Date: June 12, 2018  
To: Cumberland Planning Board  
From: Carla Nixon, Town Planner  
Subject: Orchard Road 10 Lot Major Clustered Subdivision – Preliminary & Final Approval

Date June 13, 2018  
To Town of Cumberland Planning Board  
From Carla Nixon, Town Planner  
Subject **Preliminary and Final Plan Review: Major 10 Lot Subdivision –Orchard Road**

Subject: Orchard Road Subdivision  
Orchard Road  
Final Major Subdivision Plan

7

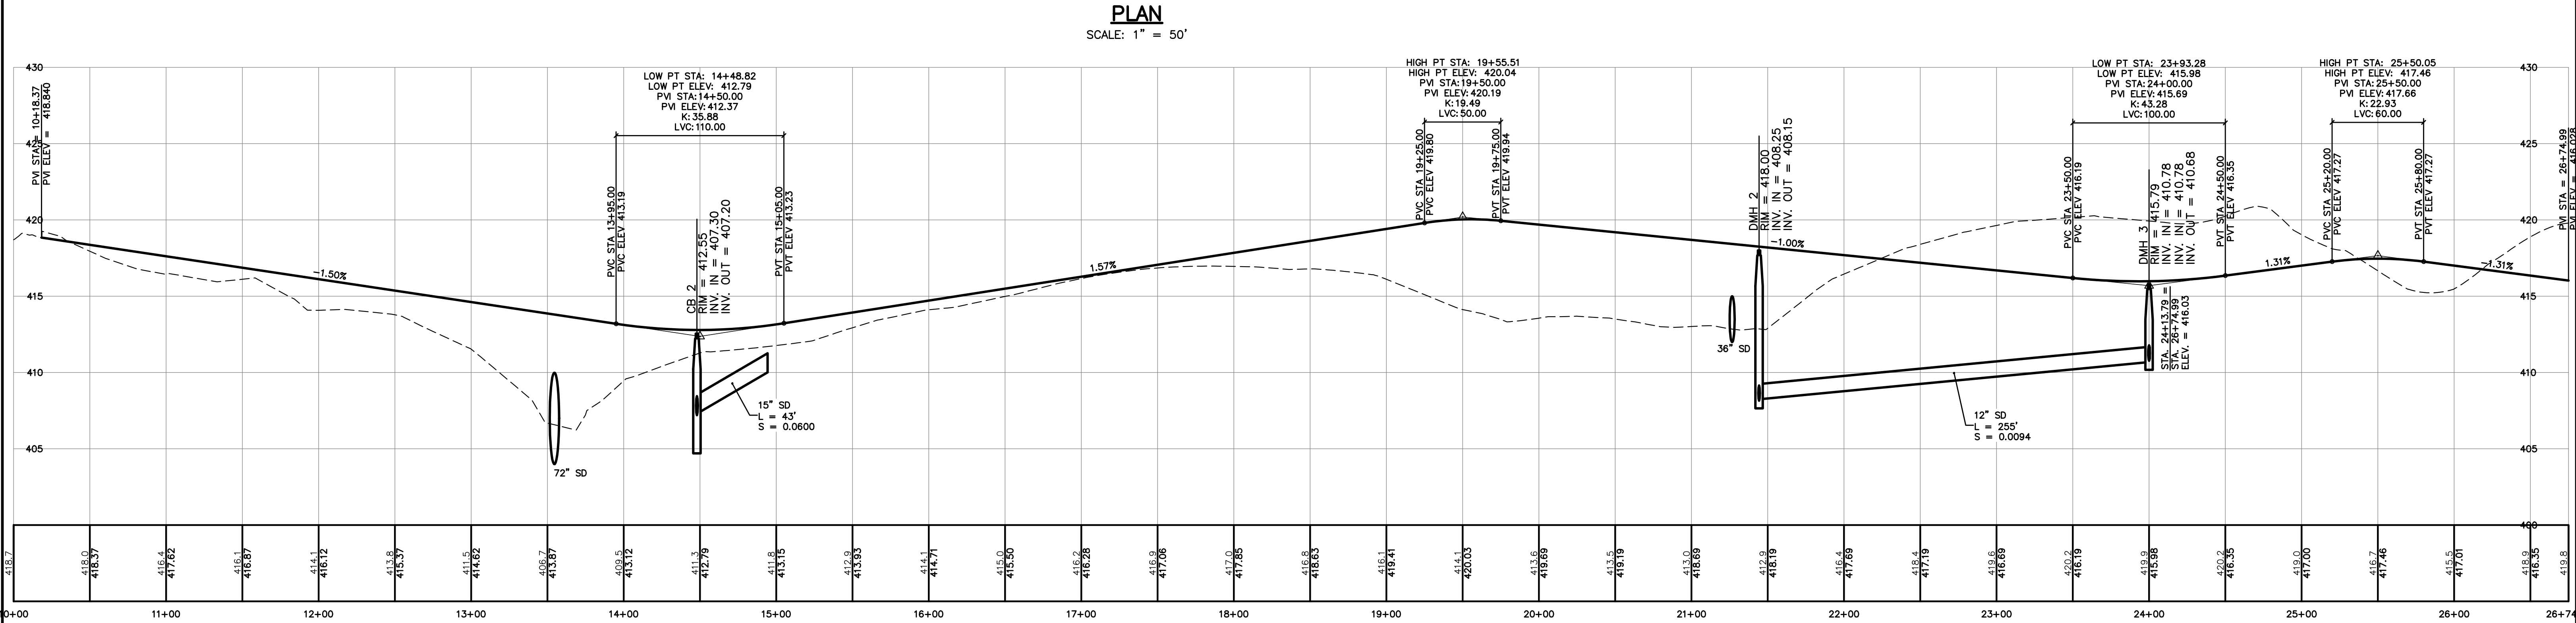
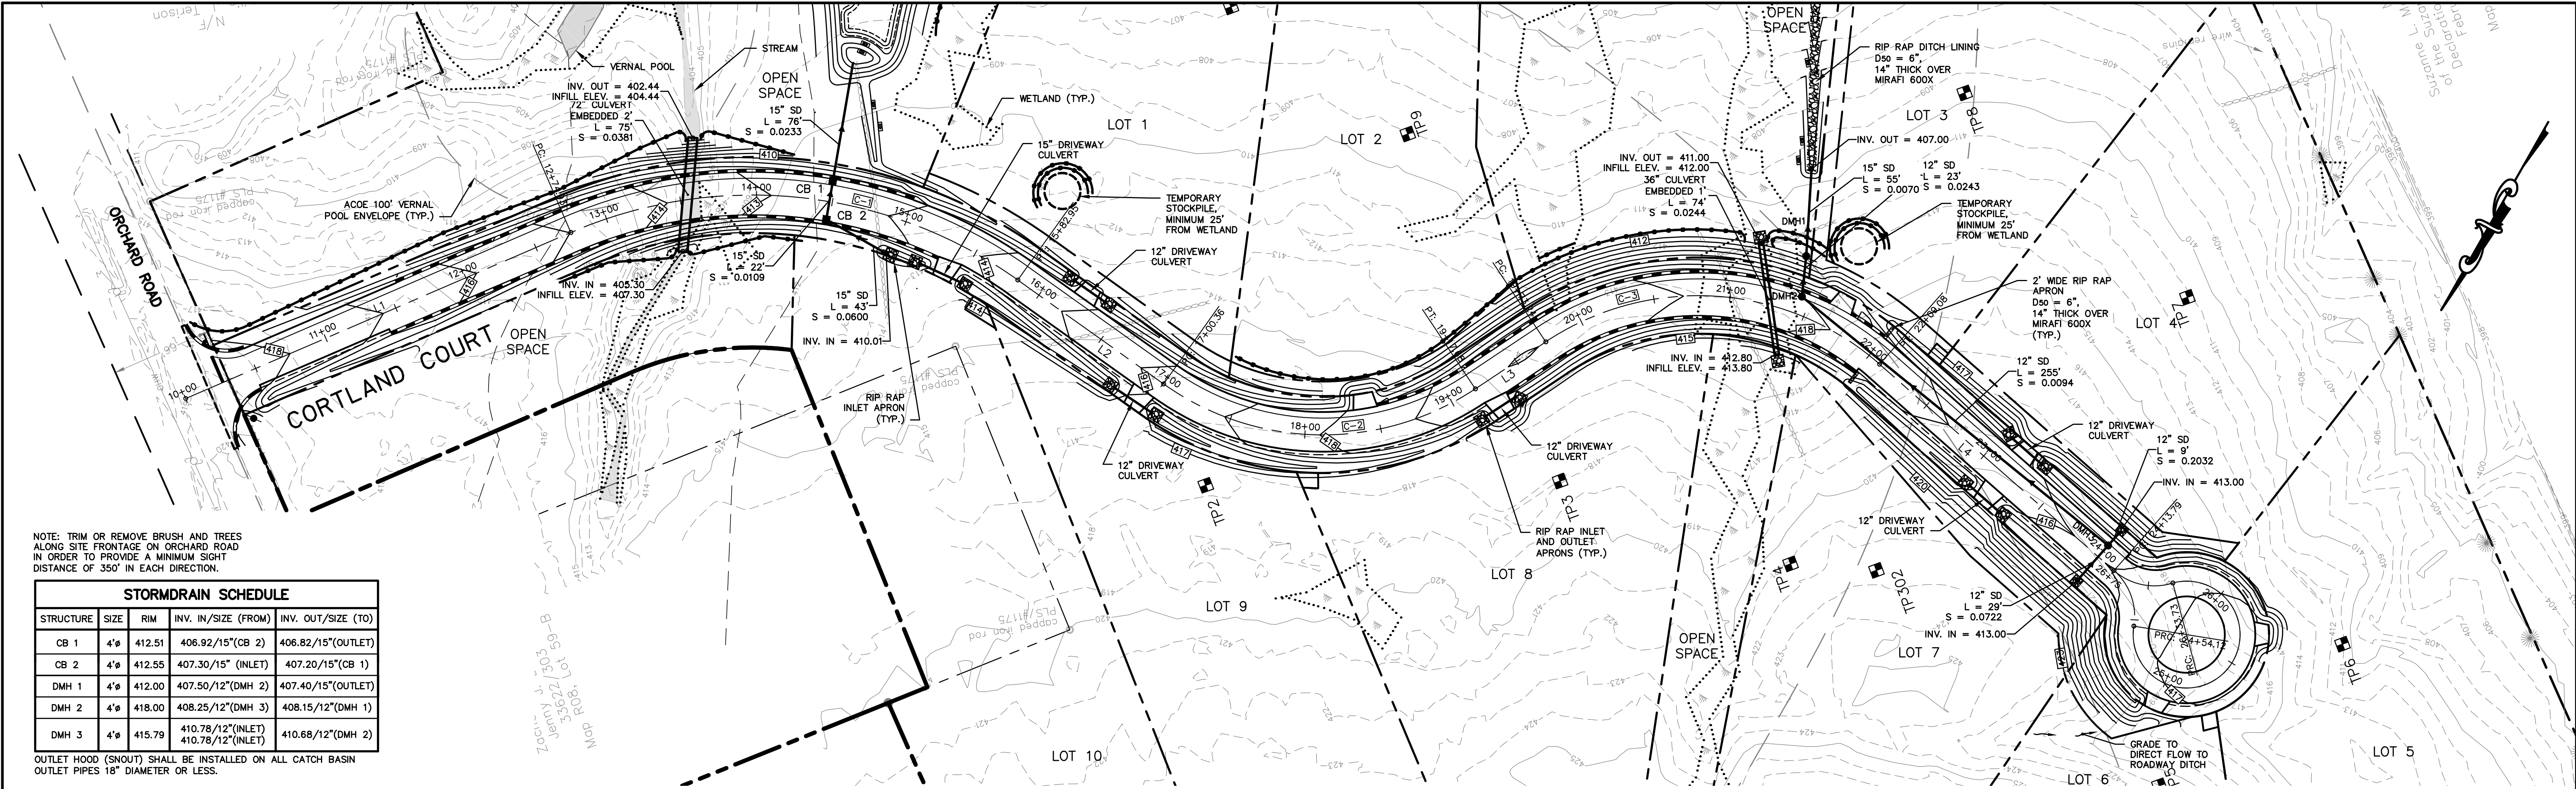
1. The curb locations shown on the road sections on Drawing No. 10 do not appear to match the curb locations shown on Drawing No. 7.

***Response: Drawing 10 will be revised to reflect the curb locations shown on Drawing 7.***
